**WESTSIDE COMMUNITY CENTER
2932 S IH Frontage Road
New Braunfels, TX 78130**

ADA SELF-EVALUATION FACILITY SURVEY

New Braunfels Westside Community Center

Jun 29, 2021

#37 Priority 1: Accessible Routes

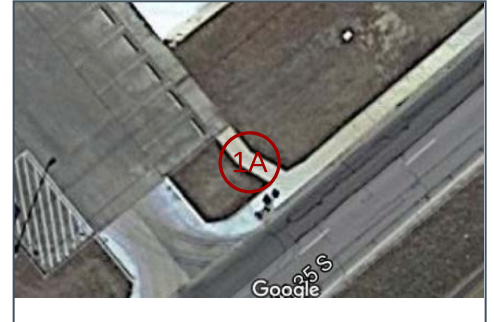
Sidewalk has a cross slope of approximately 2.6%.

Recommendation: Remove and replace sidewalk.

#38 Priority 1: Accessible Routes

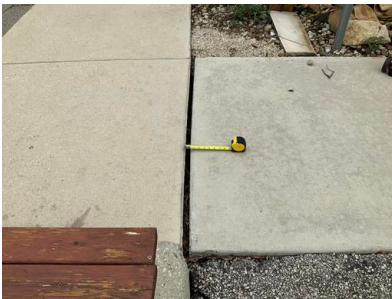
A portion of the sidewalk has
a cross slope of up to 2.7%,
excessive gaps and
excessive change in level.

Recommendation: Remove
and replace sidewalk. (2
panels, 50 SF)

#40 Priority 1: Accessible Routes

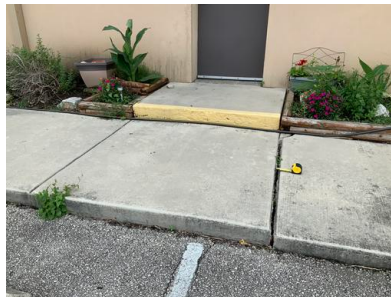
Sidewalk has approximate 1" wide openings between panels in two locations.

Recommendation: Add caulking material.

#41 Priority 1: Accessible Routes

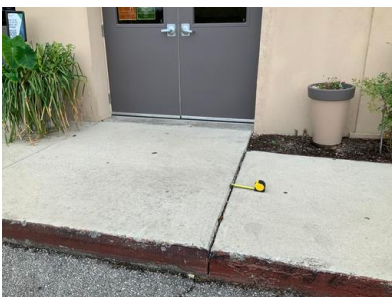
Description
Sidewalk has approximate 1"
wide openings between
panels in two locations.

Recommendation: Add
caulking material.

#36 Priority 1: Parking

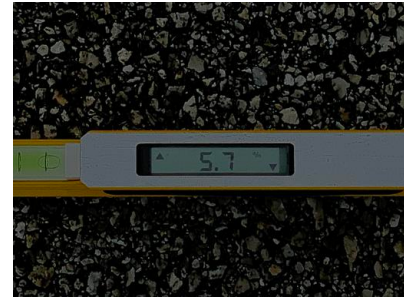
All 4 accessible parking spaces and access aisles have running slopes ranging from 4.3% to 5.9% and a crack in the asphalt.

Recommendation: Remove and replace asphalt in this area.

#1 Priority 2: Accessible Routes

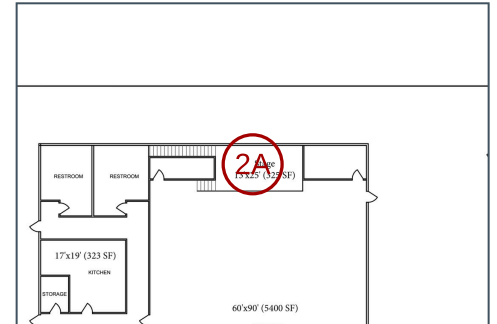
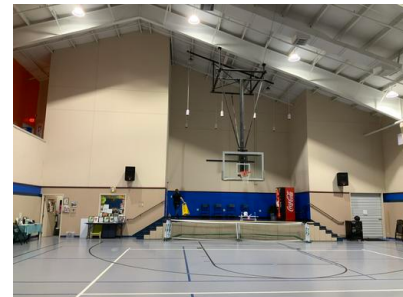
No accessible route is provided to the stage or vending machines.

Recommendation: Install a platform lift for access to the stage.

#7 Priority 2: Counters

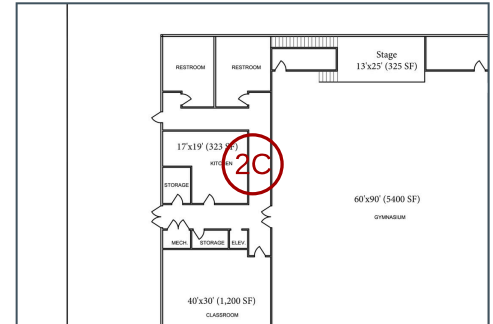
Description
The kitchen serving counter is 35" high.

Recommendation: Modify at least a portion of counter to a maximum 34" height.

#4 Priority 2: Doors

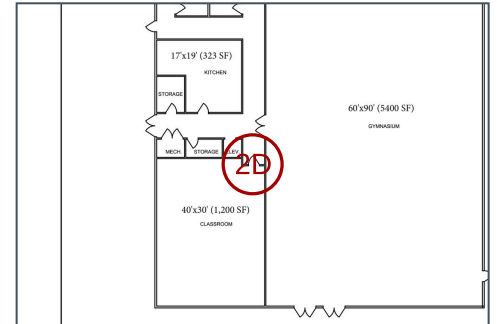
Description
Door has only 16" of clearance past the latch on the pull side.

Recommendation: Modify door configuration to provide a minimum 18" clearance past the latch.

#25 Priority 2: Doors

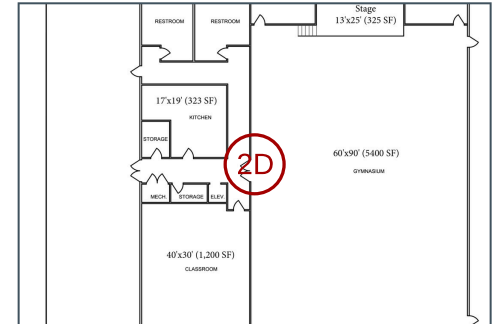
Two sets of double doors have vision panels positioned with the bottom of the glass 44" high.

Recommendation: Replace doors with ones have vision panels positioned with the bottom no more than 43".
(Note: If the doors were installed prior to March 15, 2012, they may enjoy safe harbor until replaced.)

#28 Priority 2: Doors

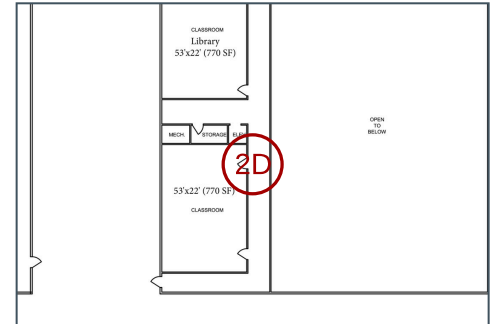
Description
Vision panels in 4 doors have the bottom of the glass positioned 45-1/2" high.

Recommendation: Replace doors with ones have vision panels positioned with the bottom no more than 43".
(Note: If the doors were installed prior to March 15, 2012, they may enjoy safe harbor until replaced.)

#27 Priority 2: Elevators

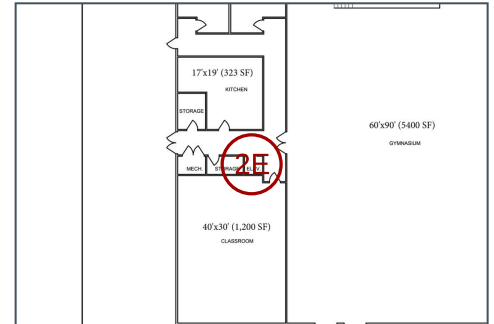
The emergency alarm button is centered 31" high.

Recommendation: Relocate panel with alarm button 35" high minimum.

#35 Priority 2: Reach Range

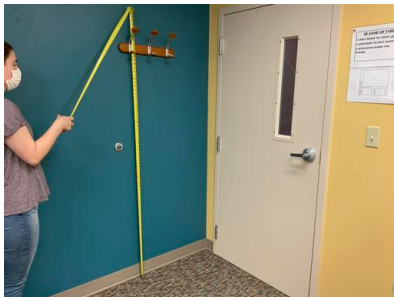
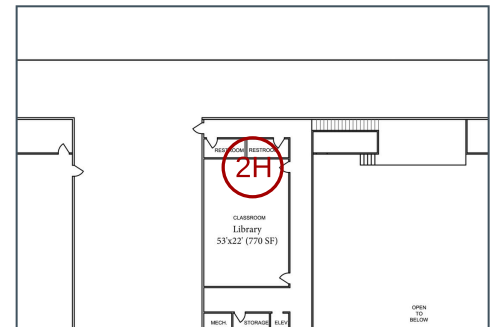
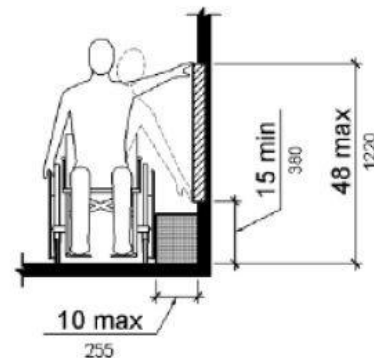
Coat hooks are positioned 66" high.

Recommendation: Install at least one hook no higher than 48".

#3 Priority 2: Protruding Objects

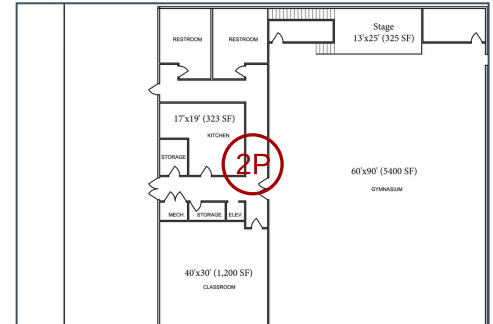
The bleeding control kit projects 10" at 45" high.

Recommendation: Relocate or add cane barrier below.

#5 Priority 2: Protruding Objects

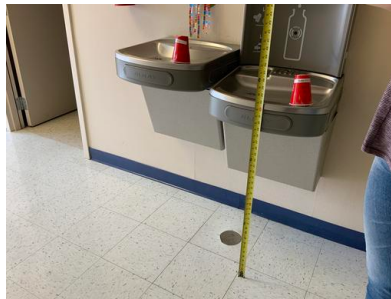
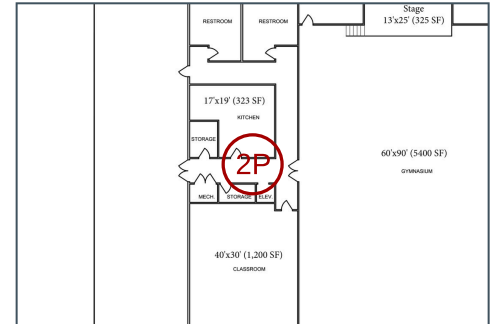
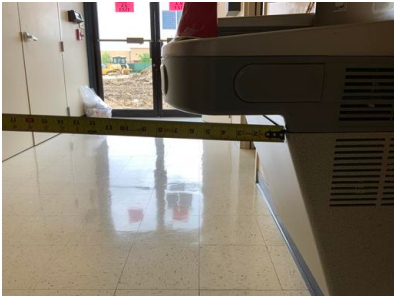
Drinking fountains project approximately 7" from the base at 28-1/2" and 32" high.

Recommendation: Lower accessible fountain so the bottom of the apron is exactly 27", and install an apron to the high fountain.

#6 Priority 2: Protruding Objects

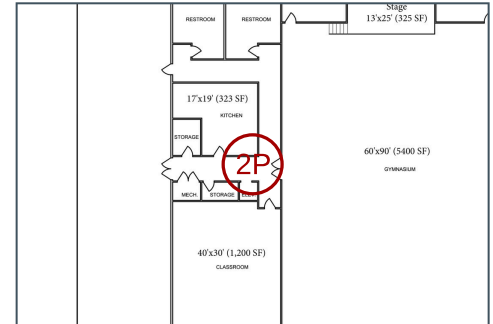
The defibrillator box projects 7-1/2" at 48" high.

Recommendation: Relocate box or install a partially recessed model.

#26 Priority 2: Protruding Objects

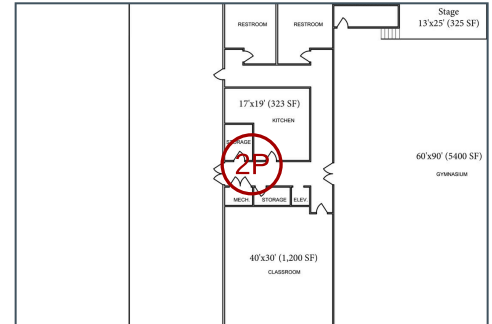
Description
Alarm panel box projects 5" from the wall at 52" high.

Recommendation: Provide cane barrier below.

#29 Priority 2: Protruding Objects

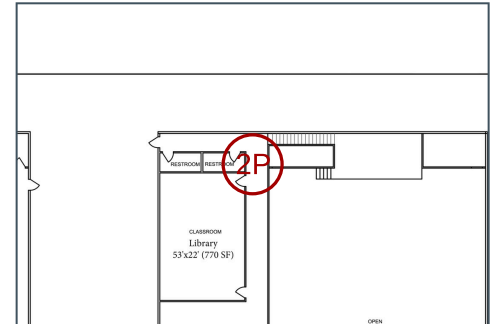
The high drinking fountain projects approximately 7" from the base at 33" high.

Recommendation: Install an apron to the high fountain to bring the bottom to no more than 27" high.

#15 Priority 3: Baby Changing Stations

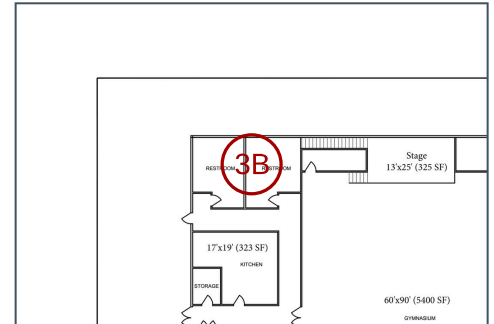
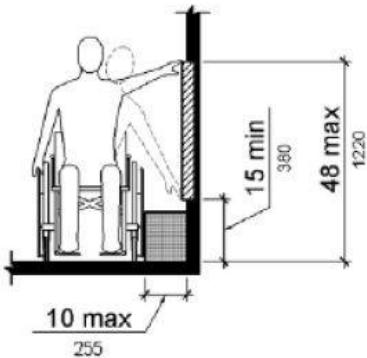
The baby changing station requires a side reach height of 51" to open and has a surface slope of approximately 7.5% within the clear floor space.

Recommendation: Replace baby changing station and locate it where the floor is level and outside of circulation paths. TDLR requires baby changing stations to be considered in their open position when considering protruding objects.

#12 Priority 3: Toilet Compartments

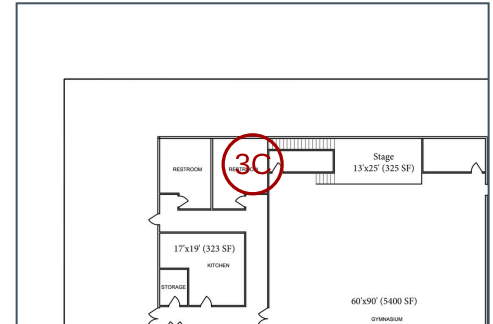
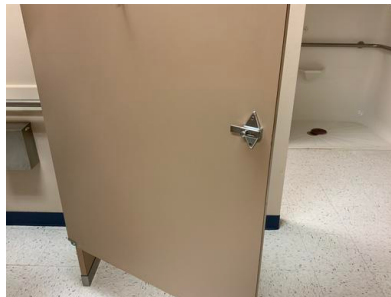
The door to the wheelchair accessible toilet stall is not self-closing and does not have a pull on the inside.

Recommendation: Adjust door hinges. Install door pull.

#21 Priority 3: Toilet Compartments

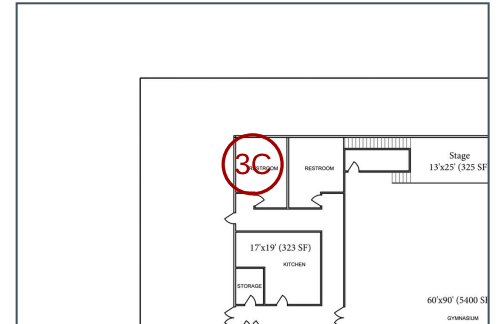
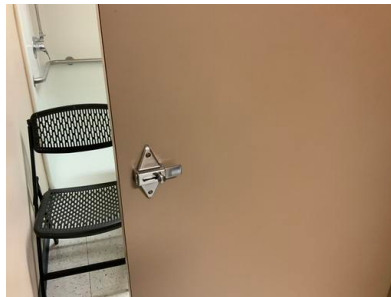
The door to the wheelchair accessible toilet stall is not self-closing and does not have a pull on the inside.

Recommendation: Adjust door hinges. Install door pull.

#8 Priority 3: Doors

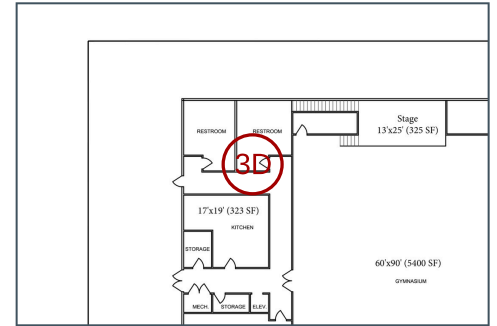
Restroom entry door has only 51" of side approach clearance.

Recommendation: Modify toilet partitions to provide a full 54".

#17 Priority 3: Doors

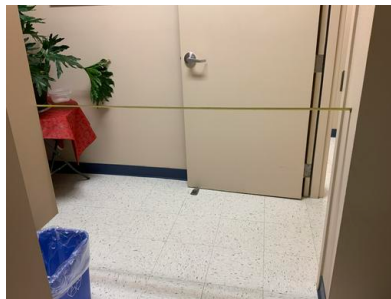
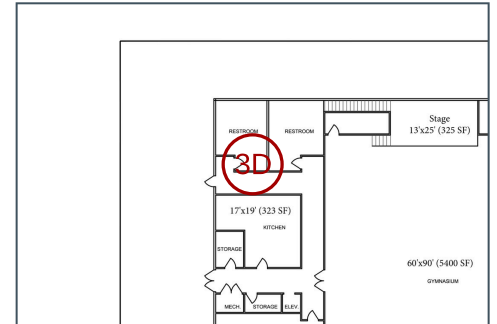
Description
Restroom entry door has only 53" of side approach clearance.

Recommendation: Modify toilet partition to provide a full 54".
Note: Due to the relatively low severity of the issue, this correction may be considered low priority.

#30 Priority 3: Doors

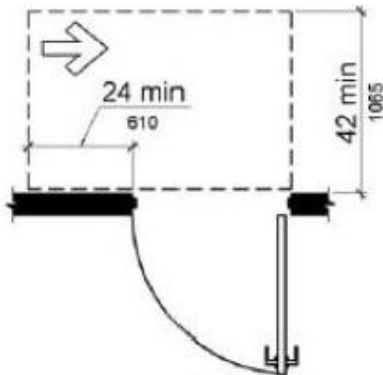
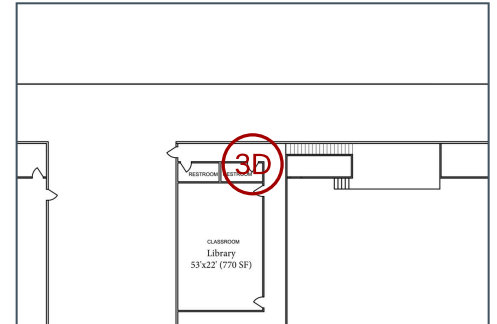
The door has a side approach width of only 40-1/2".

Recommendation: Install automatic door opener.
Alternatively, replace lavatory with a more shallow fixture, swing door outward and remove closer.

#44 Priority 3: Doors

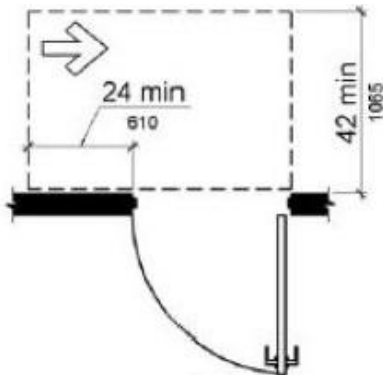
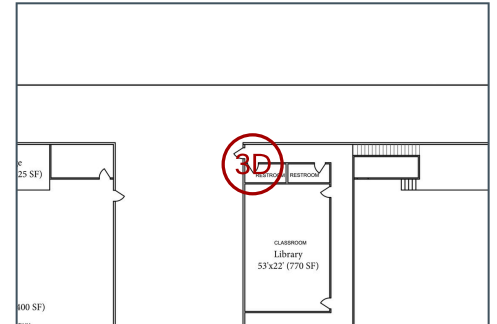
The door has a side approach width of only 39-1/2".

Recommendation: Install automatic door opener.
Alternatively, replace lavatory with a more shallow fixture, swing door outward and remove closer.

#14 Priority 3: Grab Bars

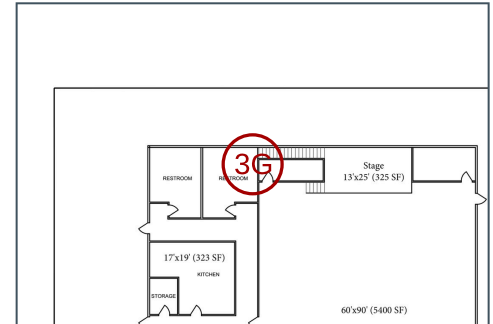
Description
The rear grab bar in the wheelchair accessible toilet stall has only 1" of clearance below the bar.

Recommendation:
Reposition bar to 1-1/2" above toilet tank.
(Note: If this element was installed prior to March 15, 2012, it may enjoy safe harbor until replaced.)

#22 Priority 3: Grab Bars

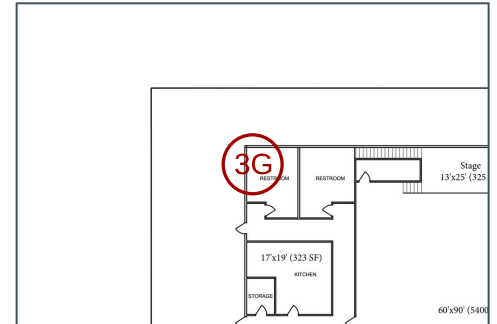
The rear grab bar in the wheelchair accessible toilet stall has only 1" of clearance below the bar.

Reposition bar to 1-1/2" above toilet tank.

#34 Priority 3: Grab Bars

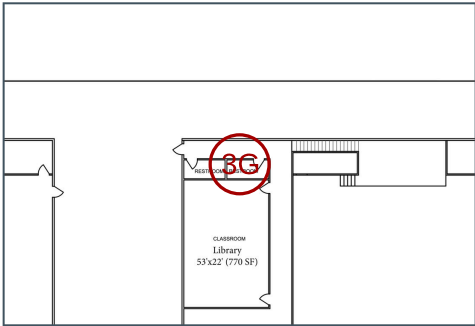
Description
The side grab bar is only 36" long and extends only 48" from the rear wall.

Recommendation: Replace with a minimum 42" long grab bar extending 54" from the back wall.

#50 Priority 3: Grab Bars

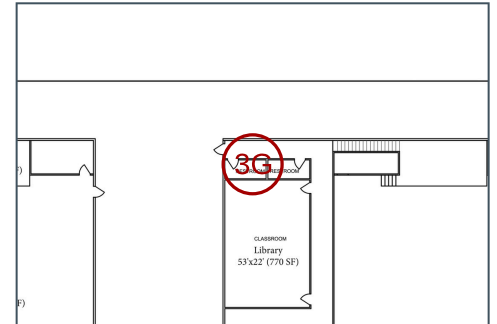
The side grab bar is only 36" long and extends only 48" from the rear wall.

Recommendation: Replace with a minimum 42" long grab bar extending 54" from the back wall.

#16 Priority 3: Showers

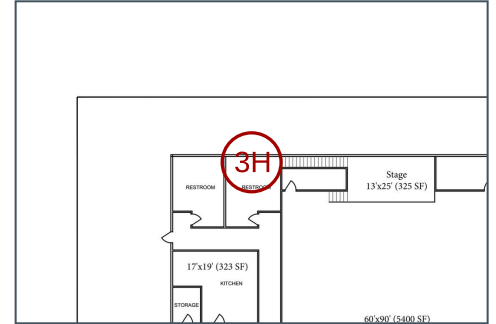
The accessible shower is not equipped with a handheld shower wand (missing), and the knob adjustment requires tight grasping and twisting of the wrist.

Recommendation: Install a compliant handheld shower assembly.

#24 Priority 3: Showers

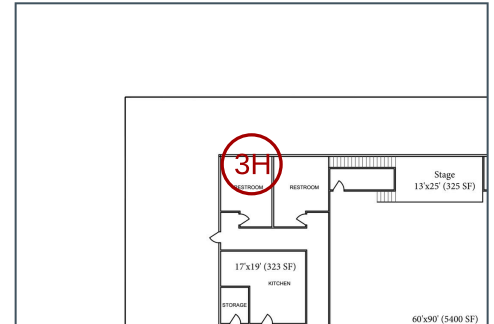
The accessible shower is not equipped with a handheld shower wand (missing), and the knob adjustment requires tight grasping and twisting of the wrist.

Recommendation: Install a compliant handheld shower assembly.

#9 Priority 3: Lavatories

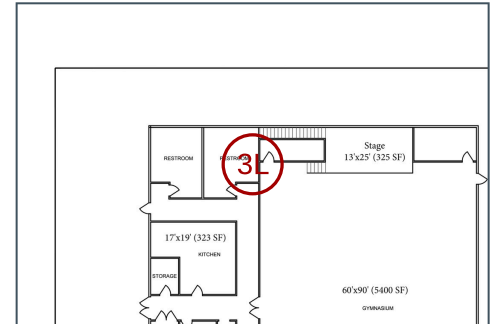
The lavatory has a rim height of 35" and no knee space below.

Reconfigure lavatory with rim 34" high maximum and knee and toe space for a forward approach.

#19 Priority 3: Lavatories

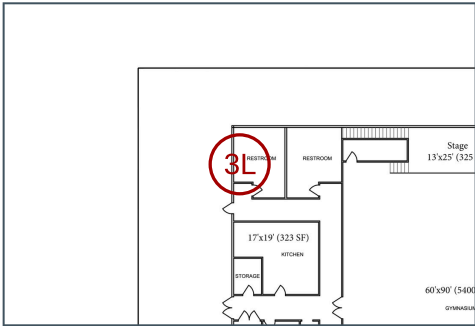
Description
The lavatory has a rim height of 35" and no knee space below.

Recommendation:
Reconfigure lavatory with rim 34" high maximum and knee and toe space for a forward approach.

#32 Priority 3: Lavatories

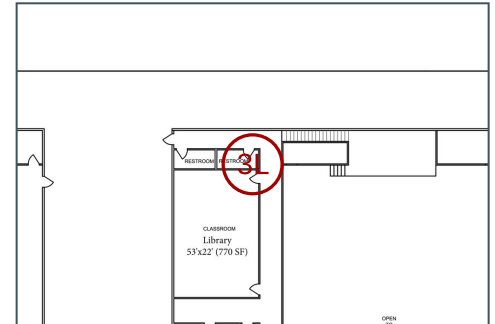
Lavatory drainpipes do not have insulation.

Recommendation: Install pipe insulation kit.

#46 Priority 3: Lavatories

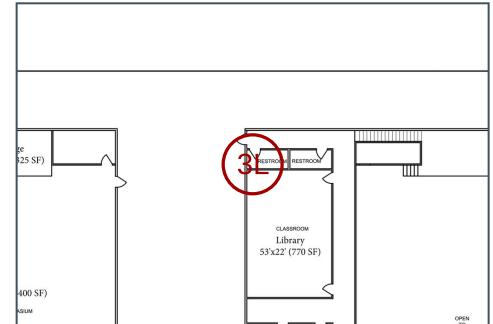
Lavatory drainpipes do not have insulation.

Recommendation: Install pipe insulation kit.

#18 Priority 3: Protruding Objects

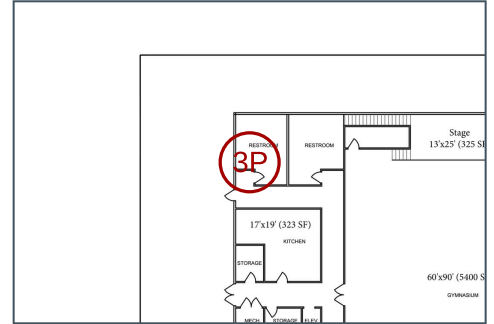
The paper towel dispenser projects 9" at a 47" high.

Recommendation: Relocate dispenser.

#11 Priority 3: Reach Range

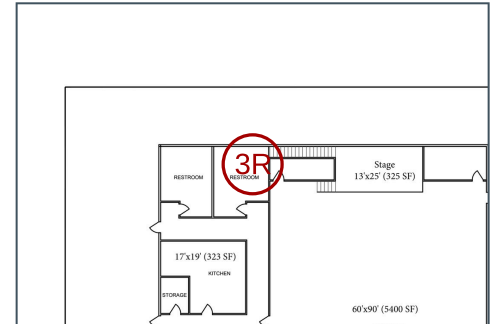
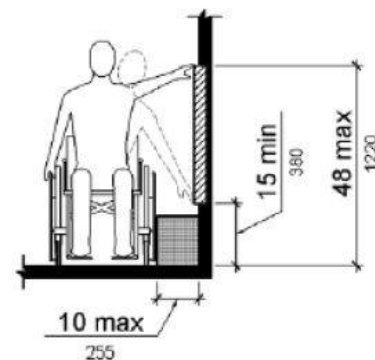
Description
The coat hook in the wheelchair accessible toilet stall is mounted 53" high.

Recommendation: Install hook at a maximum height of 48".
(Note: If this element was installed prior to March 15, 2012, it may enjoy safe harbor until replaced.)

#20 Priority 3: Reach Range

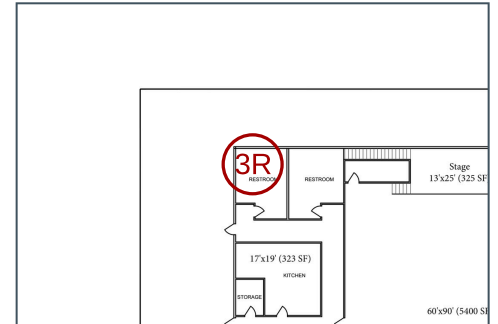
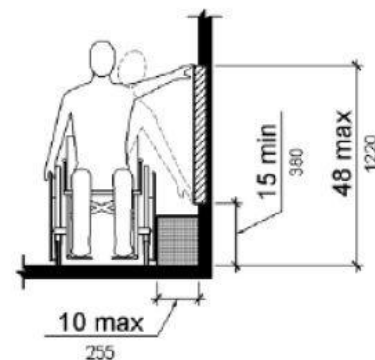
The coat hook in the wheelchair accessible toilet stall is mounted 53" high.

Recommendation: Install hook at a maximum height of 48".

#31 Priority 3: Reach Range

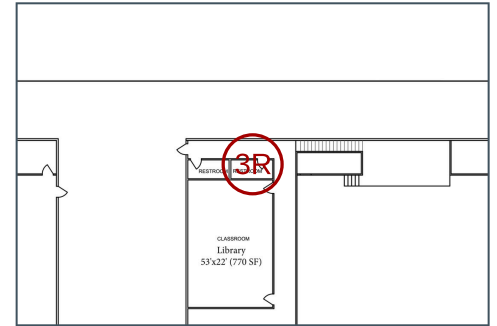
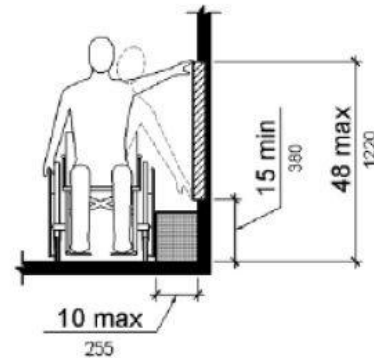
Coat hook is mounted 68" high.

Recommendation: Install a coat hook no higher than 48".

#45 Priority 3: Reach Range

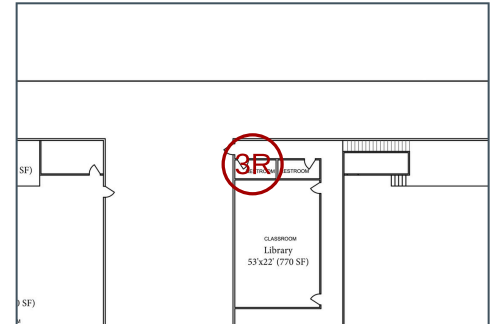
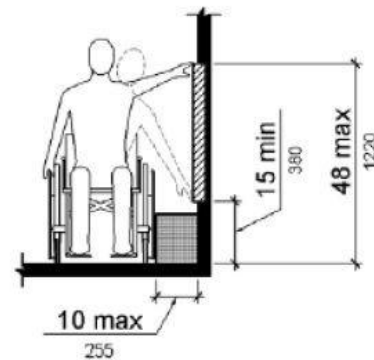
Coat hook is mounted 68" high.

Recommendation: Install a coat hook no higher than 48".

#13 Priority 3: Water Closets

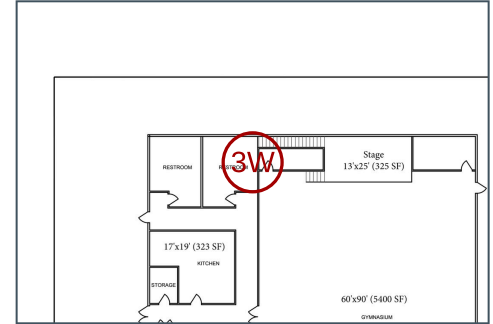
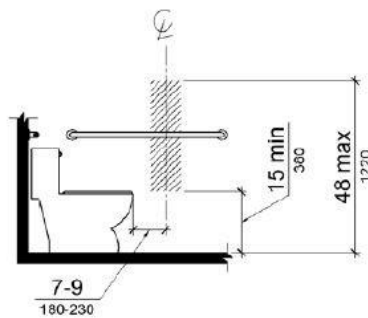
The toilet paper dispenser in the wheelchair accessible toilet stall is centered 4" from the front of the water closet.

Reposition dispenser with centerline 7" to 9" in front of water closet.

#23 Priority 3: Water Closets

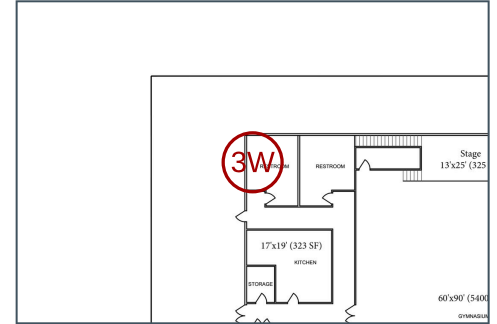
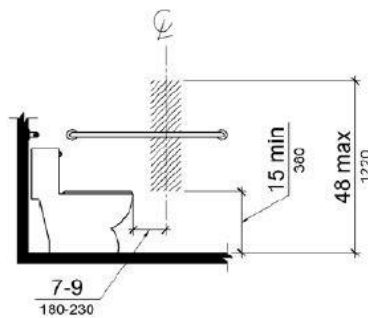
The toilet paper dispenser in the wheelchair accessible toilet stall is centered 4" from the front of the water closet.

Reposition dispenser with centerline 7" to 9" in front of water closet.

#33 Priority 3: Water Closets

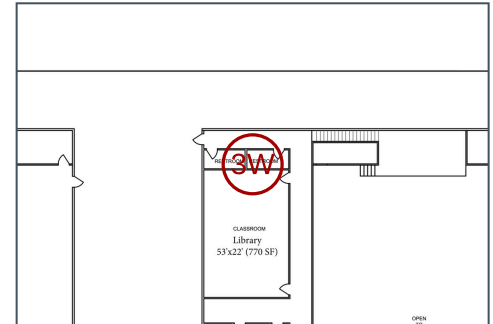
Water closet is centered
18-1/2" from side wall and
seat height is only 16".

Recommendation: Replace
water closet and install with
centerline 16" to 18" from
wall. Ensure seat height of
17" to 19".

#42 Priority 3: Water Closets

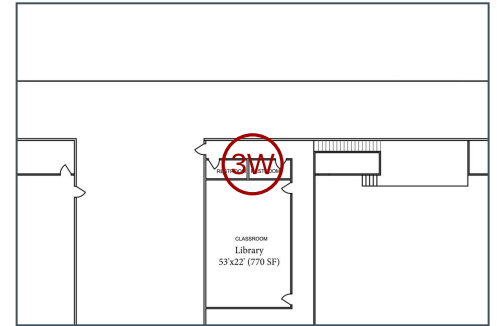
The toilet paper dispenser is centered 4" from the front of the water closet.

Reposition dispenser with centerline 7" to 9" in front of water closet.

#43 Priority 3: Water Closets

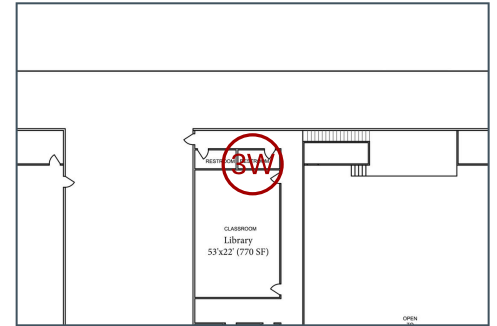
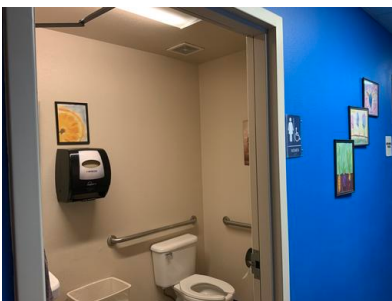
The paper towel dispenser overlaps the 60" wide clear floor space at the water closet.

Recommendation: Relocate paper towel dispenser outside of required water closet clearance.

#47 Priority 3: Water Closets

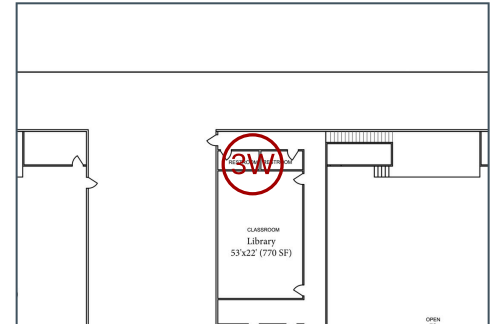
Water closet has a seat height of only 16", and the flush is mounted on the wall side of the fixture.

Recommendation: Replace water closet.
